Technical Note - Response to HCC Comments

- 1.1 This Technical Note has been prepared to provide a response to comments from Hampshire County Council (HCC) in relation the main and emergency site access and to the Internal Layout as shown on the Illustrative Plan (Appendix , which have been prepared to support the outline planning application for the proposed development of the Blue Star Land, Berewood, Waterlooville.

Grainger PLC
Blue Star Land, Berewood, Waterloooville
Technical Note – Response to HCC Comments Part B

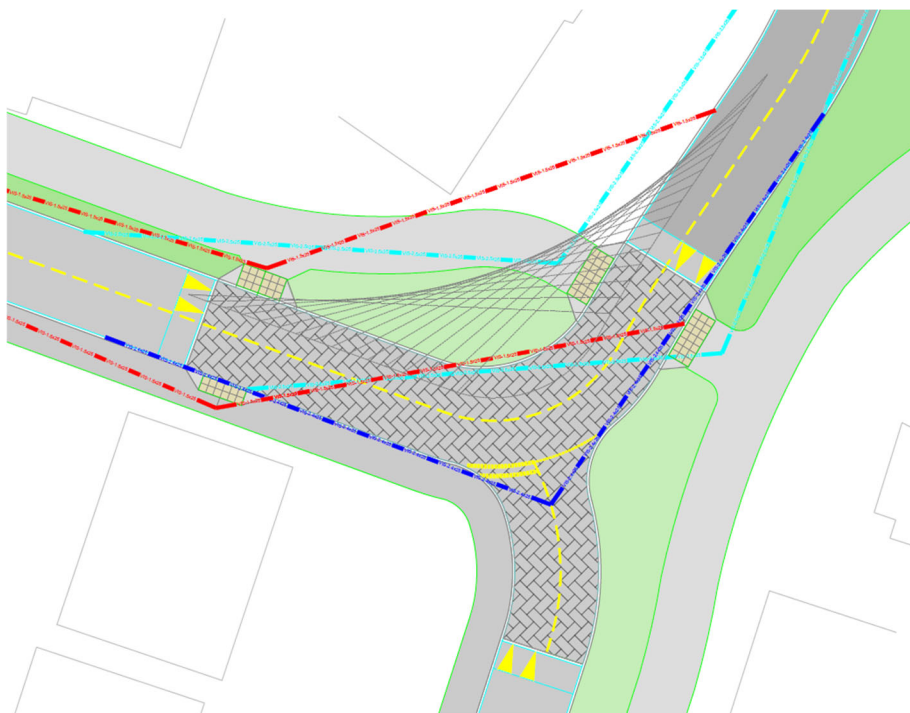
Any cycle provision should be LTN 1/20 compliant.

- 1.16 Cyclists approaching the cycle route from Laxton Leaze will be able to join the segregated route via a defined transition within a shared use area with speed reduction ramps. Cyclists joining Laxton Leaze to go west will need to cross to the southern side of the carriageway but traffic flows (Refer to 1.3 above) into and out of the development will cause minimal disruption.

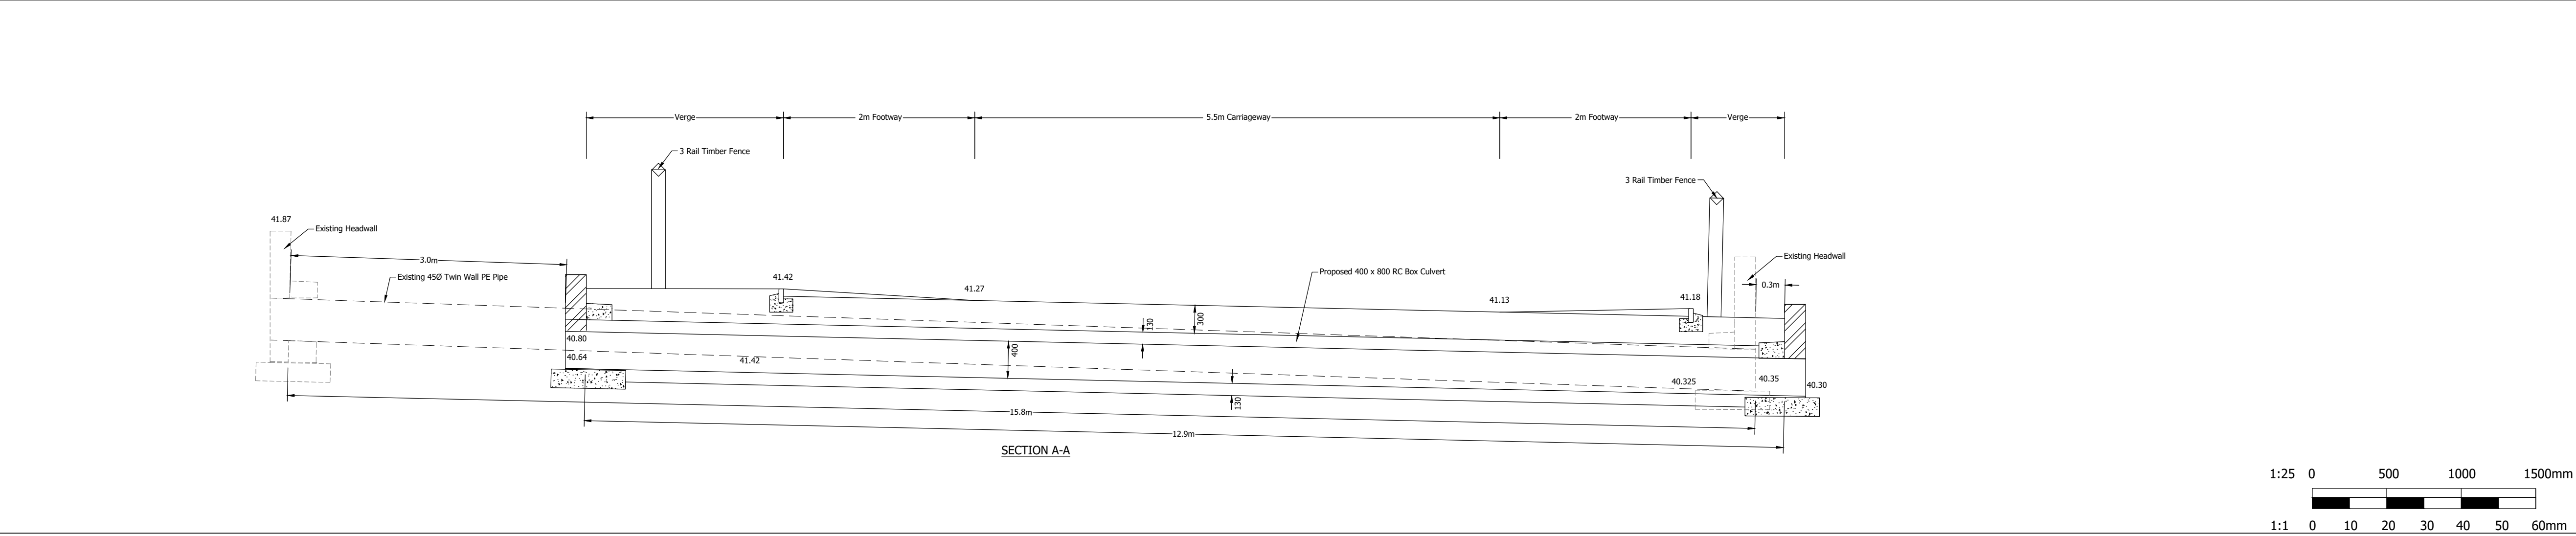
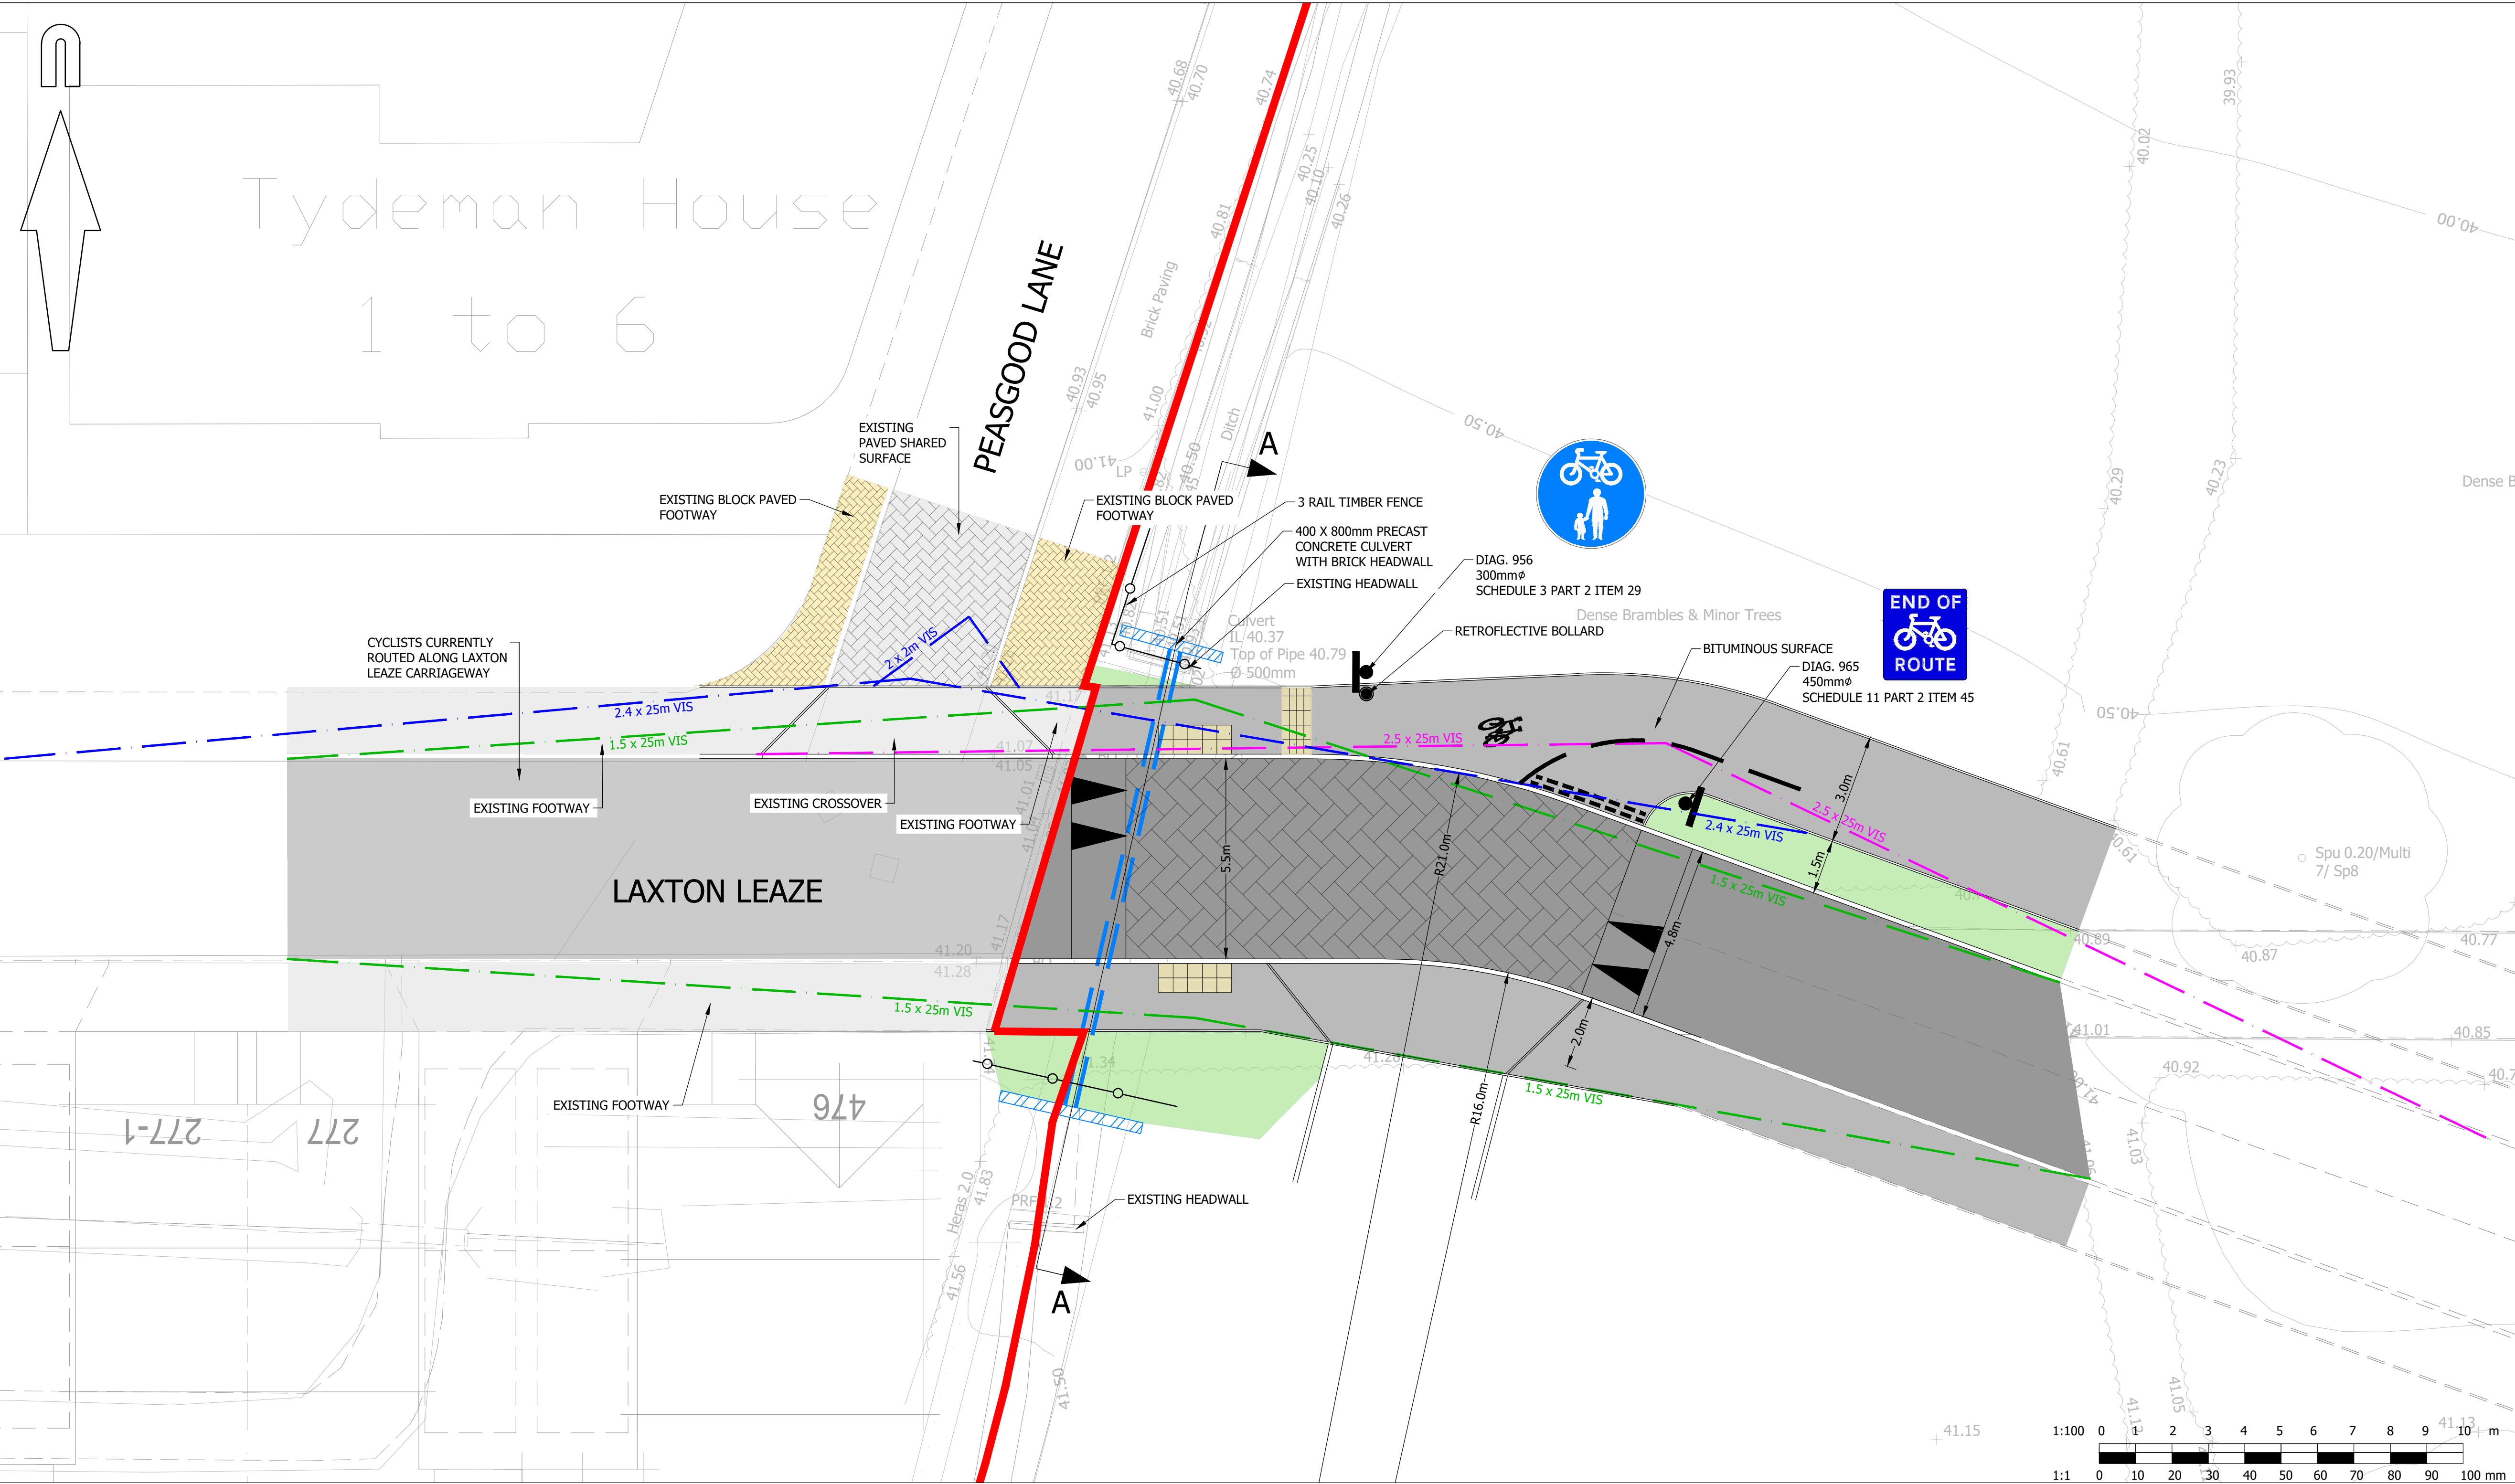
- Clarity is requested on the status of the attenuation basin and whether this is proposed or existing - if this is proposed, it should be explored as to how this could be rotated to provide further space for accommodation of the shared use path.

- Forward visibility will be required around bends at a minimum of 25.0m for a 20mph design speed.
- Turning heads will be required for refuse and fire tender.

- The location of carriageway could run parallel to the cycleway with full segregation.
- As discussed, the cycleway has been diverted off its existing desire line reducing the attractiveness of use – further consideration should be given towards this shared use path to ensure that this continues to accord with desire lines and whether the internal arrangement of the site be designed around the shared use connections. Consideration should be given to providing a similar arrangement to that which is currently being proposed for Phases 9C11A for a tree lined segregated shared use path where crossing points have been minimised.

1.38 The attenuation basin is proposed and will be constructed as part of the development drainage solution. The basin has been reduced in size by distributing additional storage in

other areas of the site. The original clearance of 10.5m between the pond and the shared path was considered adequate. This has now increased to 32m anyway to allow for further enhancement of the open space.

- 1.39 Forward visibility requirements and adequate provision of turning heads are noted and will be provided as part of the design development. The current Illustrative Plan indicates possible positions for the turning heads.
- 1.40 Crossing points at highway junctions within the development will still be necessary. Therefore, it would be better to consider the path routes and highway routes holistically so that crossing points are located where they would be most appropriate for convenience and safety.
- 1.41 The alignment of the proposed cycle routes and the need for them to accord with current desire lines is covered in Sections 1.13 to 1.25 above.

drawing number	GTWVILLE_BSL/SK/02
----------------	--------------------

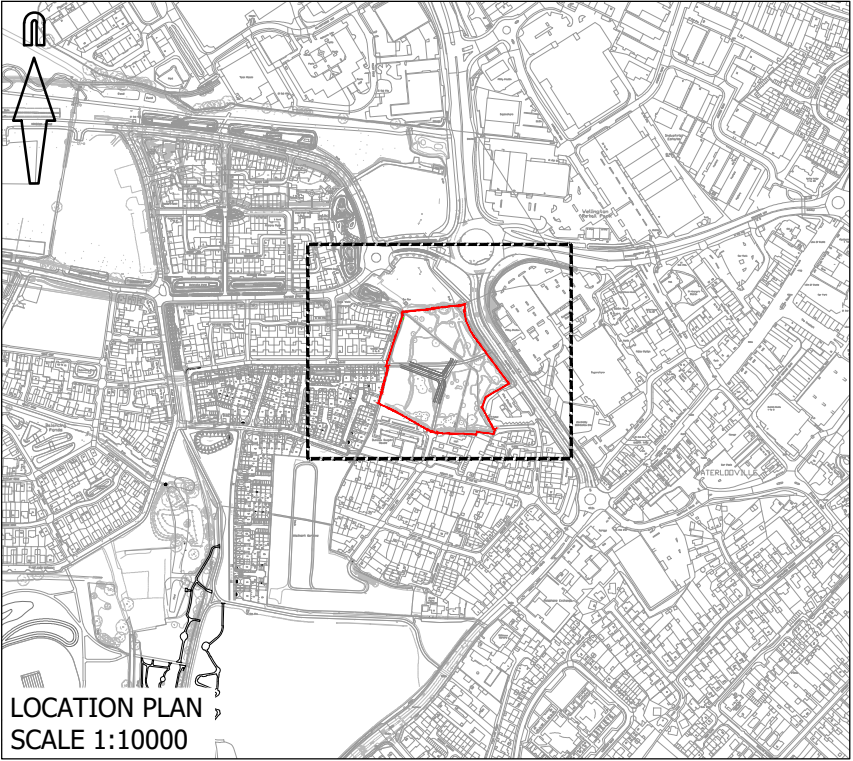
- Tie in details should be provided (for) the site access arrangements and the approved Phase 3B infrastructure along Laxton Leaze.

HCC Comment:

- Clarity requested as to whether the culvert is the existing width or whether alterations are needed.

- Visibility splays in accordance with HCC TG3 should be provided where the cycle path is proposed to drop on carriageway.

- 1.5 Dwgs. GTWVILLE_BSL/SK/02 (main access) and SK/03 (non-vehicular and emergency access).
- 1.6 SK/02 indicates how the existing shared surface at the southern end of Peasgood Lane will be maintained thereby maintaining pedestrian priority for users entering and leaving the BSL development. The entrance to the BSL site will include a raised platform serving as a shared use area where pedestrians are guided to cross and where cyclists transition from/to the Laxton Leaze carriageway to/from the proposed segregated cycle route. The raised platform and shared use surface treatment will act as a speed reduction measure where pedestrians and cyclists will be manoeuvring on or off the carriageway. Laxton Leaze north and south footways will continue into the BSL site. The northern footway will transition to a shared footway cycleway within the shared use area.

- 1.34 Dwg. GTWVILLE_BSL/SK/02 provides a cross section through the culvert. The culvert's overall length will be extended from 15.0m to 16.4m. The existing culvert is a 450 diameter twin wall PE pipe (CSA = 0.16sq.m). Cover depth under the existing footway is approximately 300mm. In order to provide sufficient support for the min access the culvert will be replaced with a modular concrete box section with a clear opening of 400mm x 800mm (CSA = 0.32sq.m). This provides a CSA greater than the existing whilst compensating for the limited cover depth.
- 1.35 The provision of the culvert will be subject to S38 and LLFA comments and will likely require an Approval In Principle (structure) report (AIP) and an Ordinary Water Course Consent (OW) application to be submitted. The review of these will influence the detail of the culvert provision.

1.37 Refer to Dwgs GTWVILLE_BSL/SK/02 and 03.
